E-Rate Category 2: Internal Connections Request for Proposals Addendum 1

Form 470 No.: 240017198

Pioneer Union Elementary School District
E-Rate Category 2 Request for Proposals: Addendum 1

Campus Map with Room Numbers

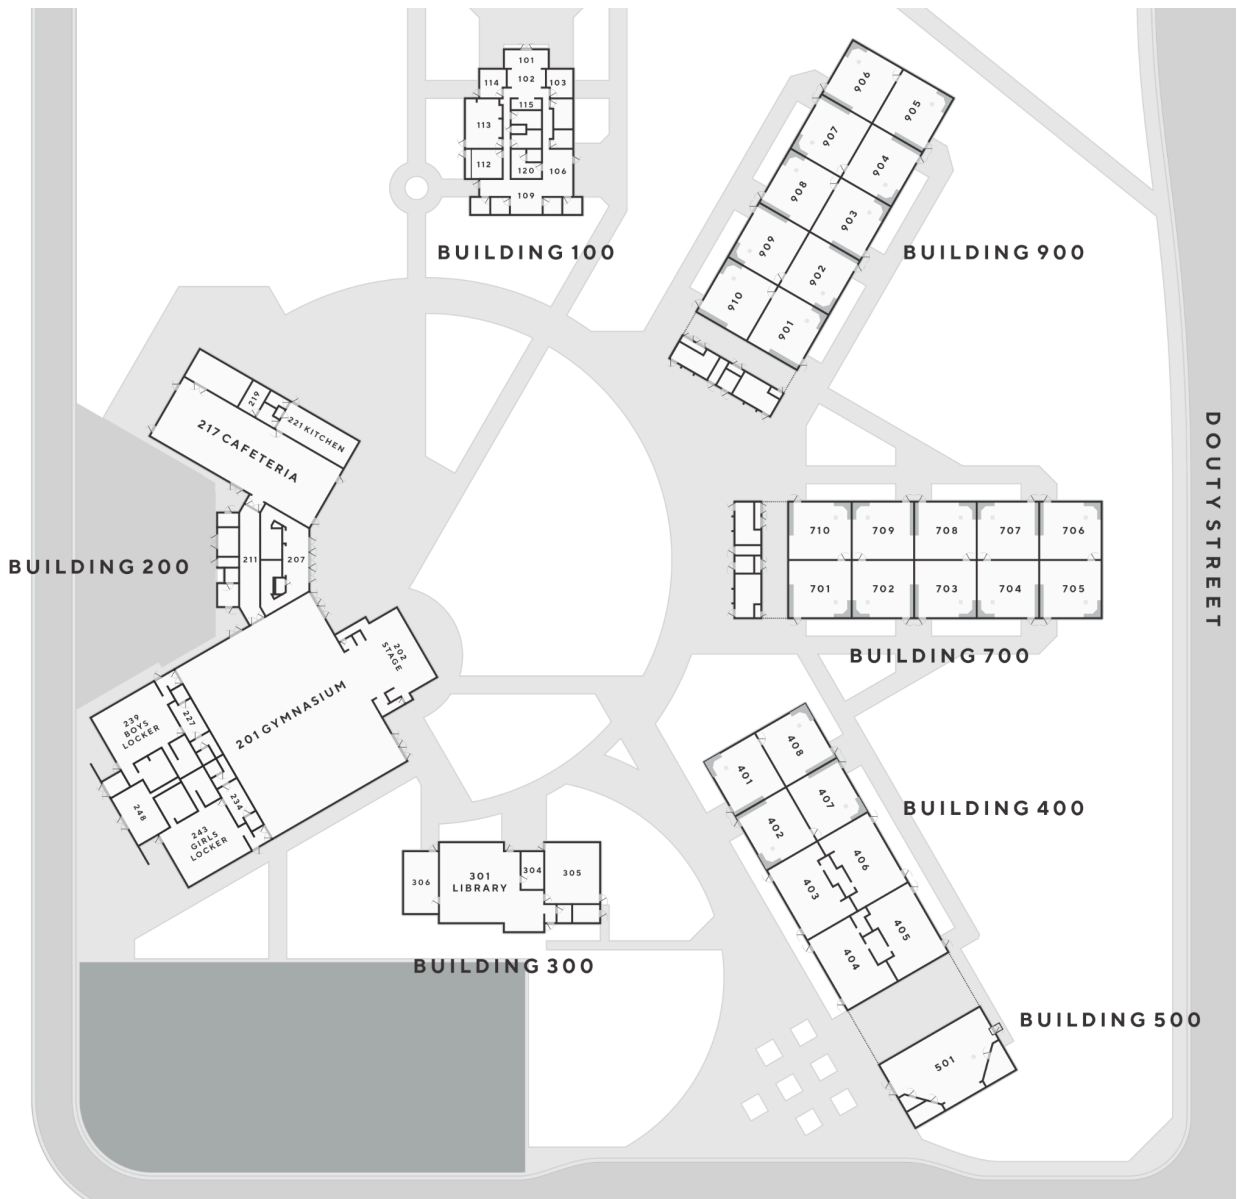
-
- 1 Question Is there a classroom layout with [ethernet] drop and location totals?

Answer Yes. Attached to this document, please see Appendix C and D at the end of this document.
